Access Compliance Report

Public Rights-of-Way

(Curb Ramps)

Intersection ID: 47965	Main Street: TURNING_HAWK_RD	Cross Street: MESA_VERDE_RD	Location: NE
ADA ID: 8BD3EB03609C	Ramp Type: PerpDiag	Initial Pass/Fail: Fail	Overall Compliance: No
Severity Score: 33.75			
Codes/Mitigation Info/Possible Solution		Field Measurements/Component Compliance

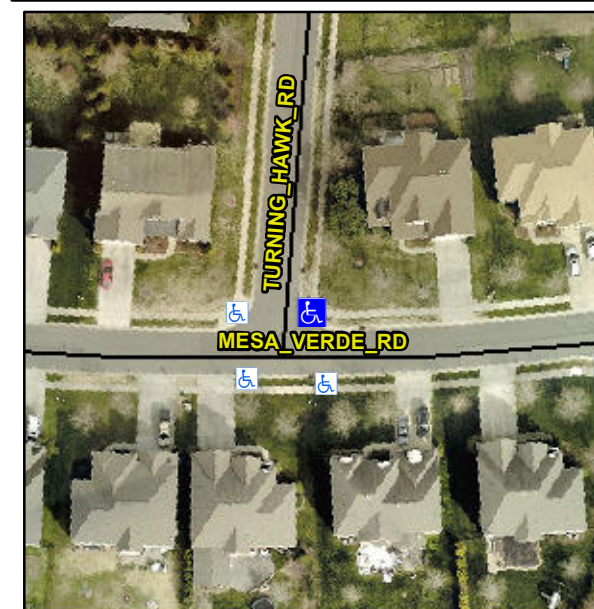
Not Found, R304.5.1, R304.2.2, R304.5.3

Compliance	Description	Data	Compliance	Description	Data
N/A	Ramp Length (in)	45.0	No	Ramp Slope (%)	10.4
No	Ramp Width (in)	46.0	No	Ramp XSlope (%)	5.4
N/A	Flare Type LT	N/A	N/A	Flare Type RT	N/A
N/A	Flare Slope LT (%)	N/A	N/A	Flare Slope RT (%)	N/A
N/A	Flare Traversable LT?	N/A	N/A	Flare Traversable RT?	N/A
N/A	Landing Length (in)	N/A	N/A	DWS Provided?	N/A
N/A	Landing Width (in)	N/A	N/A	DWS Contrast?	N/A
N/A	Landing Slope (%)	N/A	N/A	DWS Length (in)	N/A
N/A	Landing X Slope (%)	N/A	N/A	DWS Full Width?	N/A
N/A	Landing Curb? (Y/N)	N/A	N/A	DWS Offset (in)	N/A
N/A	Shared Landing?	N/A			
N/A	Gutter Ponding?	N/A	N/A	Gutter Slope (%)	N/A
N/A	Gutter Lip Ht (in)	N/A	N/A	Gutter X Slope (%)	N/A
N/A	Painted X Walk1?	No	N/A	Painted X Walk2?	No
	X Walk 1 Direction	To W		X Walk 2 Direction	To S
N/A	X Walk 1 Width (in)	N/A	N/A	X Walk 2 Width (in)	N/A
	X Walk 1 Slope (%)	1.4		X Walk 2 Slope (%)	5.0
	X Walk 1 X Slope (%)	2.8		X Walk 2 X Slope (%)	2.6

N/A	Ramp inside XWalk1?	N/A	N/A	Ramp inside XWalk2?	N/A
	Road Slope (%)	3.8	N/A	Clear Space?	N/A
	Road X Slope (%)	1.3	N/A	Clear Space to XWalk (in)	N/A
N/A	Any Obstructions?	N/A	N/A	Storm Grate/Utility Hazard?	N/A
	Obstruction Type			Storm Grate/Utility Type	
		N/A			N/A
			Yes	Surface Condition? (G/P)	Good

Remove & Replace Curb Ramp With Two New Directional Ramps or Equivalent.
